# Work Order ID 122424

# DART SERVICE INSTRUCTION

TO AMEND INSTALLATION INSTRUCTIONS D350-607-3 Rev.D,  
INSTALLATION INSTRUCTIONS D350-607-4 Rev. C AND  
INSTRUCTIONS FOR CONTINUED AIRWORTHINESS ICA-D350-607 REV. 6  
REF TCCA STC: SH94-14  
REF FAA STC: SR00213NY  
REF EASA STC: EASA.10016996  
REF BRAZILIAN STC: 2007S03-03/-04/-05/-06

A	NEW ISSUE	AJS	14.05.16
REV.	DESCRIPTION	BY	DATE
DESIGN	AJS	DART AEROSPACE LTD	
DRAWN	AJS	HAWKESBURY, ONTARIO, CANADA	
CHECKED		DRAWING NO.	REV. A
MFG. APPR. -	N/A	DSI 9699	SHEET 1 OF 2
APPROVED		TITLE	SCALE
DE APPR.		LUG REPLACEMENT	NTS
DATE	14.05.16	COPYRIGHT © 2014 BY DART AEROSPACE LTD	
THIS DOCUMENT IS PRIVATE AND CONFIDENTIAL AND IS SUPPLIED ON THE EXPRESS CONDITION THAT IT IS NOT TO BE USED FOR ANY PURPOSE OR COPIED OR COMMUNICATED TO ANY OTHER PERSON WITHOUT WRITTEN PERMISSION FROM DART AEROSPACE LTD.

**FIGURE 1: INSTALLATION OF D4775-041 FWD STRUT**

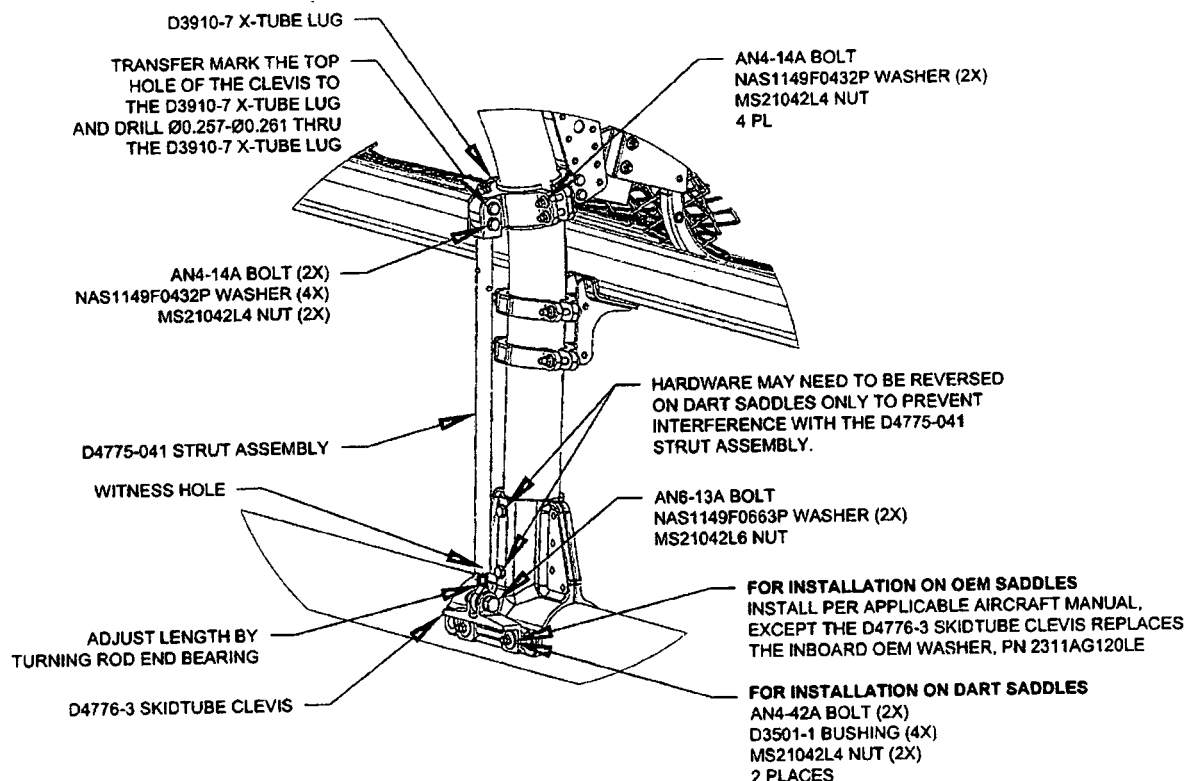
3.1 Substitute the Forward Lower D3910-5 X-Tube Lug with the D3910-7 X-Tube Lug as shown in Figure 1.

3.2 Install the forward D4775-041 Strut Assembly. Transfer mark from the upper hole on the clevis of the D4775-041 Strut Assembly to the D3910-7 X-tube Lug and drill thru the lug  $\varnothing 0.257$ - $\varnothing 0.261$  as shown in Figure 1. Touch up chemical conversion coating per MIL-DTL-5541. Check the witness holes located at the bottom end of the D4775-041 Strut Assemblies to ensure that the thread from the rod end extends past the witness hole.  
**Torque MS21042L4/-4 nuts to 50-70 in-lbs (5.7-7.9 N-m). Torque MS21042L6/-6 nuts to 160-190 in-lbs (18.1-21.5 N-m).**
